Ref: 016/2022

**YOUR REFERENCE: DA2021/1808**  
**PREMISES: 9 CHERYL CRESCENT, NEWPORT**

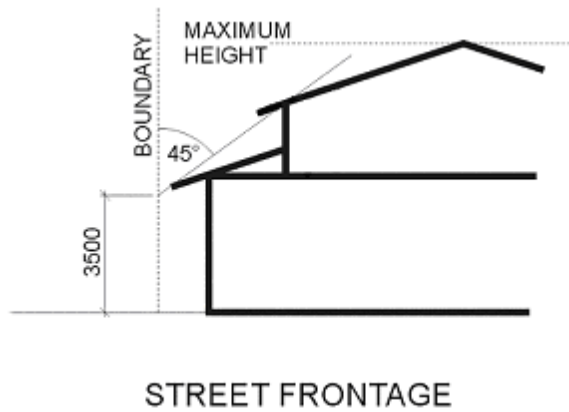
8. **Building Envelope** – The amended plans do not address clause D10.11 of the DCP. The north and east elevations (DA8 and DA10) still clearly show that the first floor has not been appropriately set back in accordance with Council's controls.

The Applicant has not addressed the detrimental impacts of this non-compliance to the amenity of our Clients' property, including bulk and scale (discussed at paragraph 4 above), acoustic privacy (paragraph 5 above) or view loss (paragraph 6 above). These amenity impacts need to be addressed through compliance with Council's building envelope controls before the application can be determined.
